Technical Note

Client Llŷr Floating Wind Ltd	Subject Llŷr Floating Wind Farm Landscape & Visual Note in Response to NRW Comments.	Date 04 November 2025	Document ref 60669422
Prepared by Nigel Weir: Associate Landscape Architect	Checked by John Devenny	Approved by Tim Newton

Project Llŷr Landscape & Visual Technical Note.

Figure 1: Comparison of ZTV of Project Llyr at 325.5m and 300m tip heights

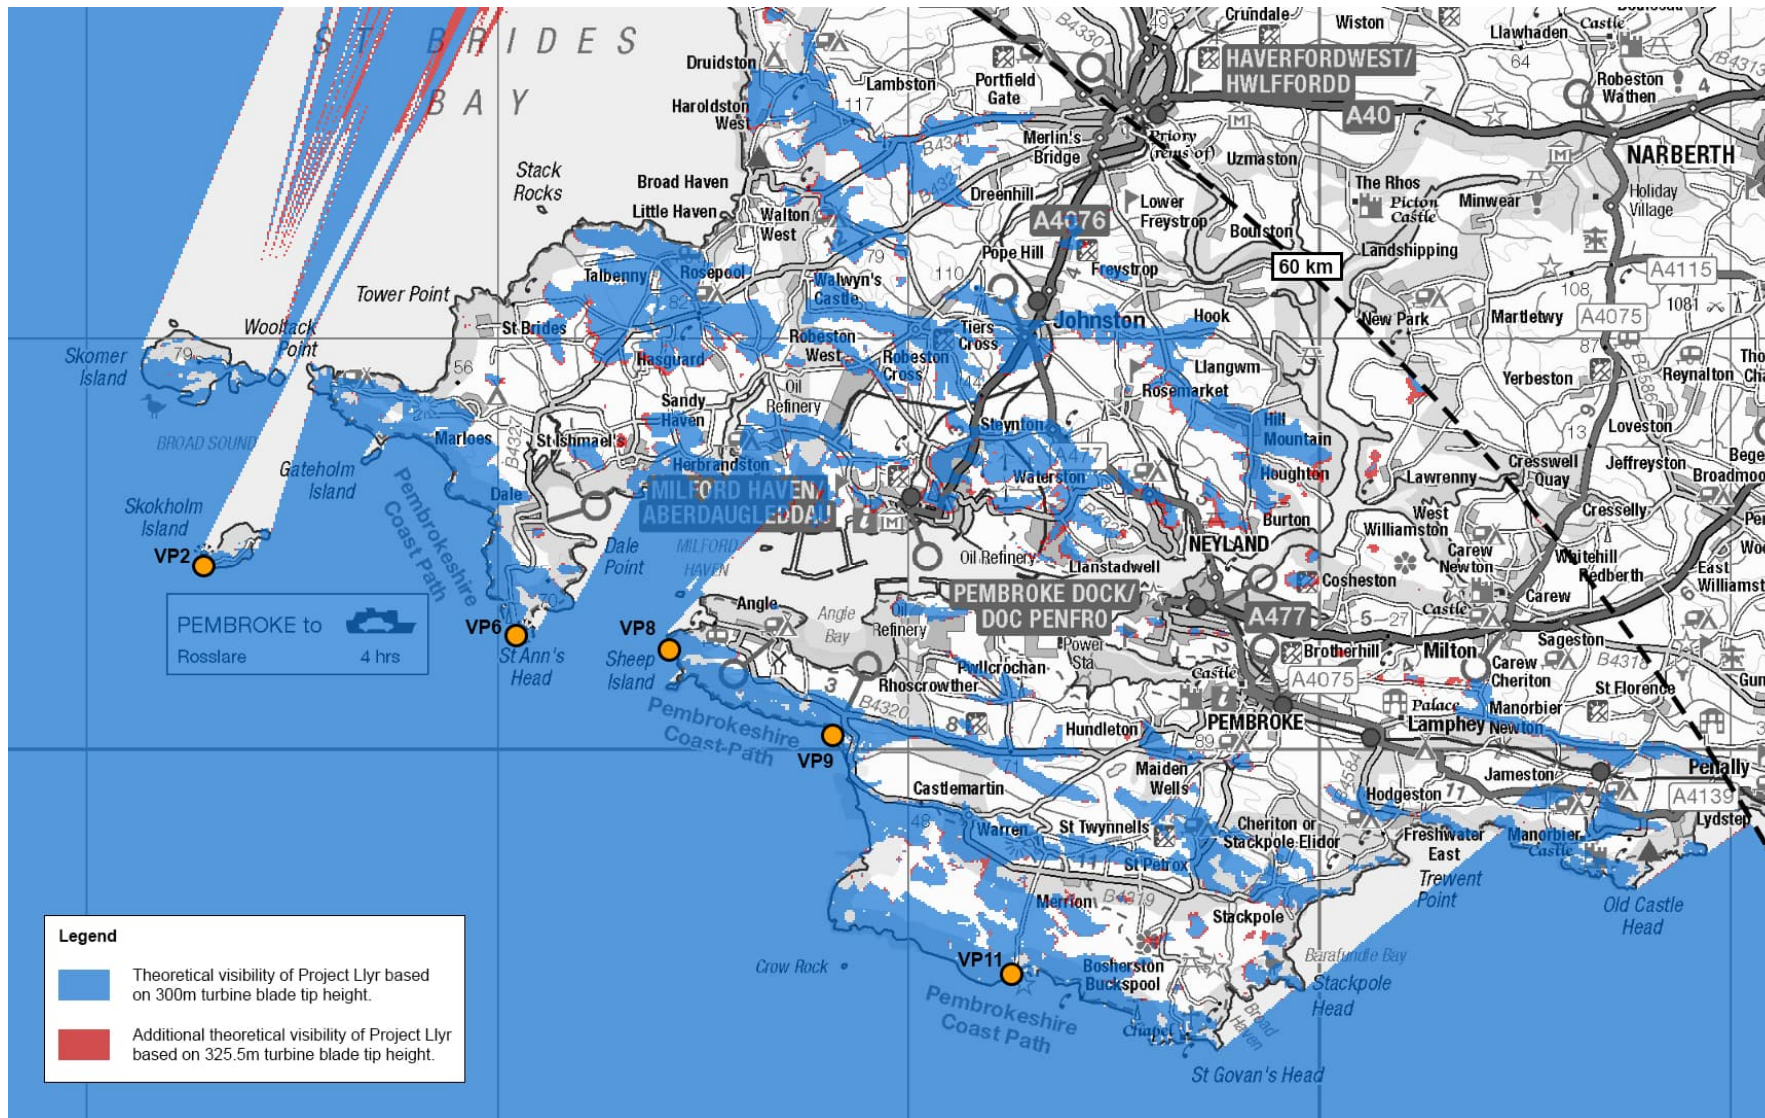
- Following the applicant's commitment to limit turbine tip height to 300m above Highest Astronomical Tide (HAT) PEDW have asked how this impacts the LVIA and the reliability of the vantage point wireframes and photomontages.

- 2.9 Reference to Figure 1: Comparison of ZTV of Project Llŷr at 325.5 and 300m tip heights shows areas shaded blue in which 300m turbines would theoretically be visible, the red shaded areas show the additional geographical extent of theoretical visibility of the 325.5m turbines. A simple visual comparison indicates that the differences in geographical extent are extremely limited such that although there is a reduced impact it would not translate into a reduction in magnitude and hence significance of effect.

Figure 2: Comparison of ZTV of Project Llŷr at 300m and 270m tip heights

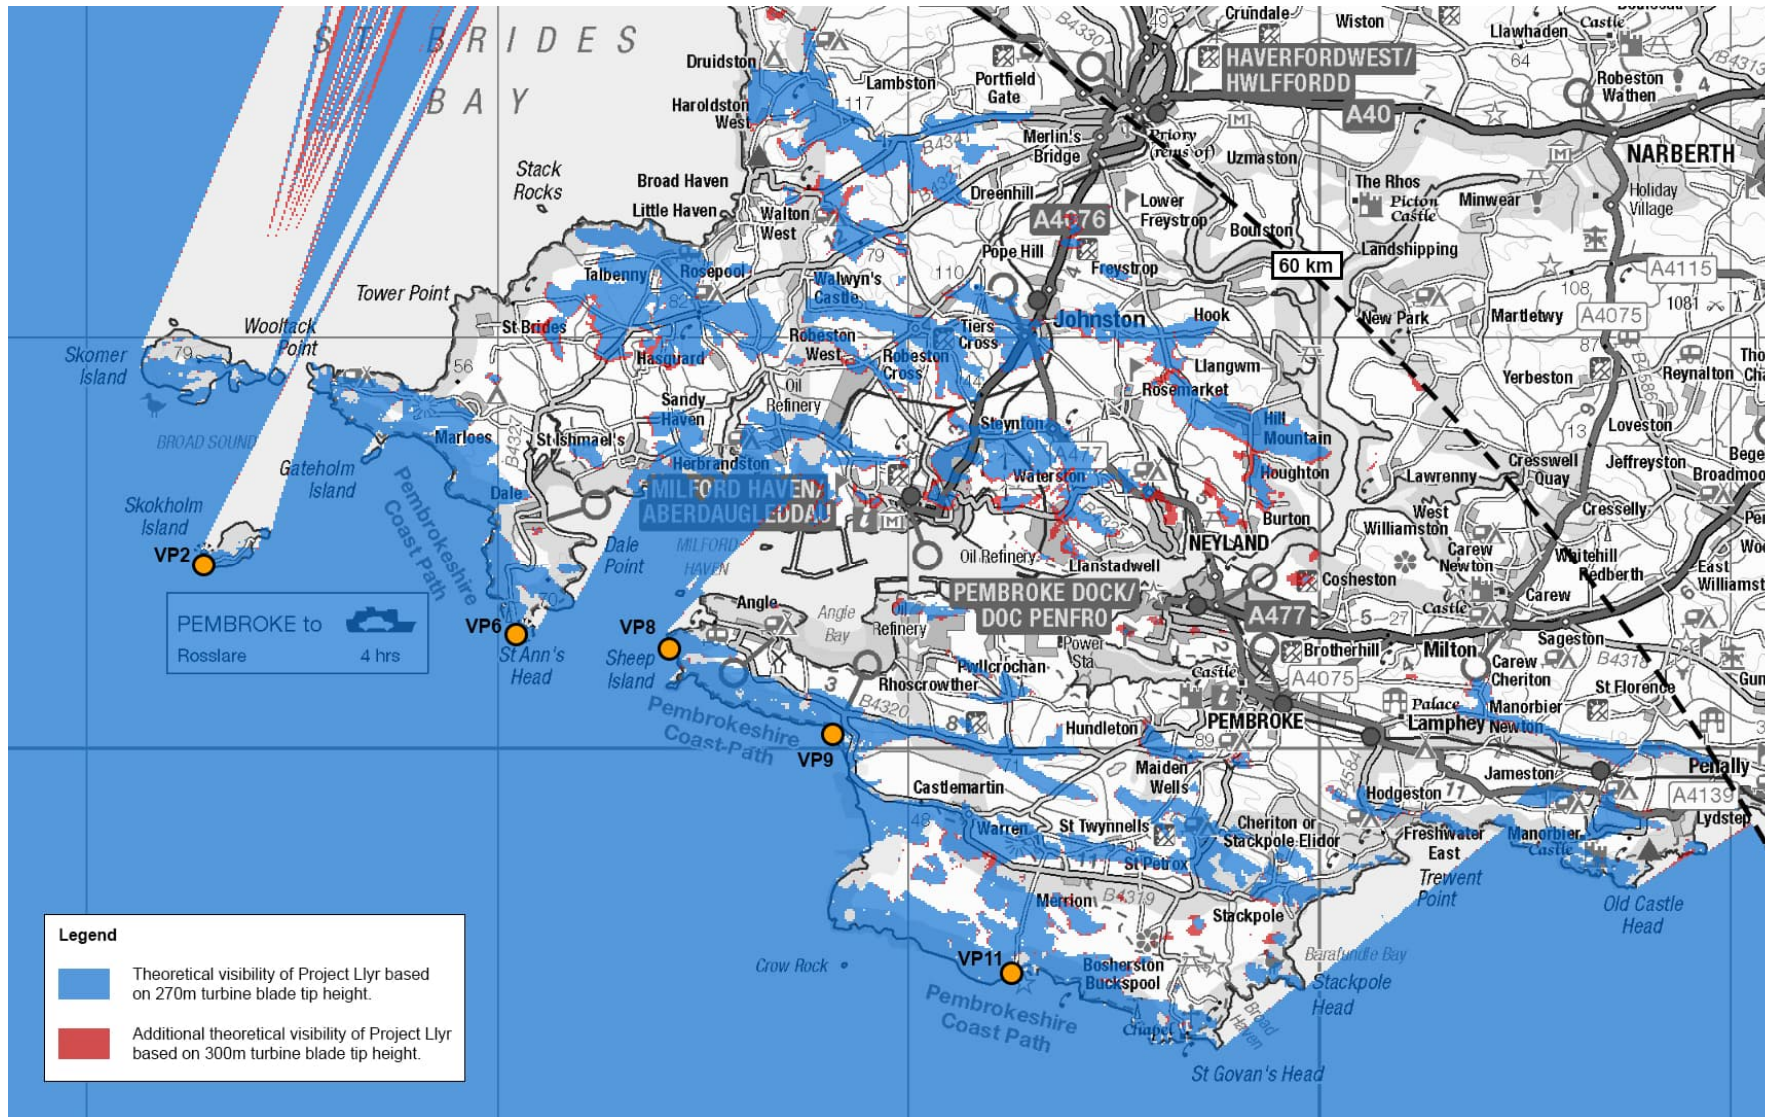
- Comment on NRW's view that to avoid adverse impact, tip height should be reduced to 270m.
- 1.4 The NRW comments in response to the LVIA, may be summarised as relating to the turbine height and impacts on the Pembrokeshire Coast National Park (PCNP), based on the content of *"Seascape and visual sensitivity to offshore wind farms in Wales: Strategic assessment and guidance Stage 1- Ready reckoner of visual effects related to turbine size"* (Simon White, Simon Michaels and Helen King, White Consultants) Report No 315, hereafter referred to as The Offshore Wind Sensitivity Guidance, 2019.

- 4.6 We consider that this is illustrated by Figure 2 showing the comparative ZTV and the range of wirelines for five of the assessment viewpoints provided in Appendix A of this technical note.

Figure 3.2 - Comparative Wireline (300m and 270m tip heights)
Viewpoint 2: Skokholm Island

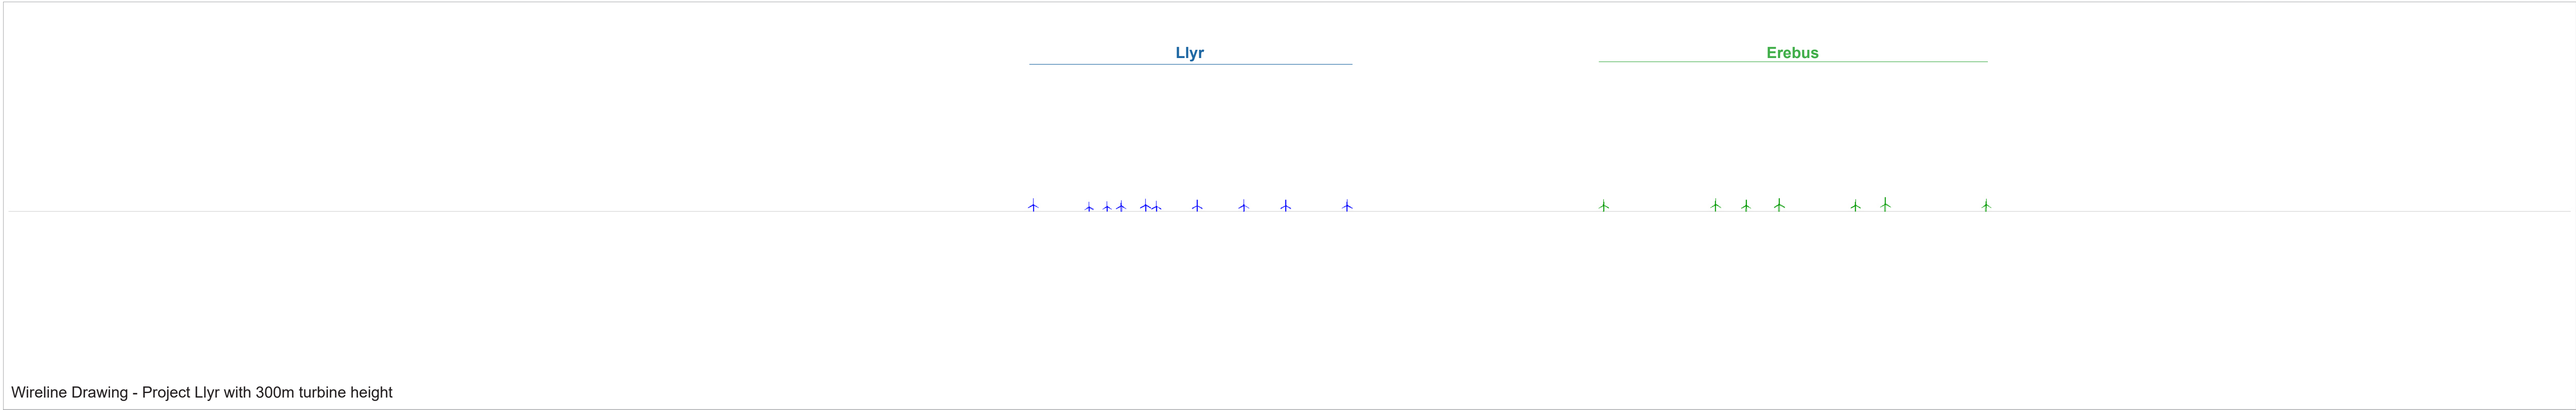
- ii. *The Array would not be located 'beyond the Stage I report low magnitude buffer distances for the highest potential turbine proposed from National Parks' which is requested when Principle 3 is not achievable (beyond 41.6 km for turbines between 226-300m). At the closest point the Array is 35 km from the PCNP. (Principle 4).*

Erebus is closer to the PCNP than Project Llŷr (VP2) by some 5 km. The angle subtended (i.e. perceived height) by the Project Llŷr turbine closest to the PCNP is 0.477 degrees (to 3 decimal places) at 36 km as opposed to an angle subtended by the 270m turbine of Erebus at 31 km of 0.499 degrees. The angles have been calculated by drawing the real-world scale in AutoCAD and measuring the angles between the viewpoint and the top of the turbine. The Erebus turbines therefore appear larger in comparison but noting that the angle subtend/perceived height is vanishingly small at less than 0.5 degree in both cases and the curvature of the earth is not included in this calculation but would, in itself, further reduce the perceived height of the furthest turbines (i.e. Project Llŷr). A second factor is that from much of the PCNP the viewpoints towards Project Llŷr or Erebus, are elevated and hence the relative perspective of height will be distorted, with turbines appearing shorter than if viewed in a horizontal plane at the same level.

Response: Erebus is closer to the PCNP than Project Llŷr (VP2) by some 5 km and as illustrated by the wirelines in Appendix A and the comparison with Erebus, as a consented scheme, closer to the PCNP, we contend that this is a meaningless comparison and arbitrary yardstick.
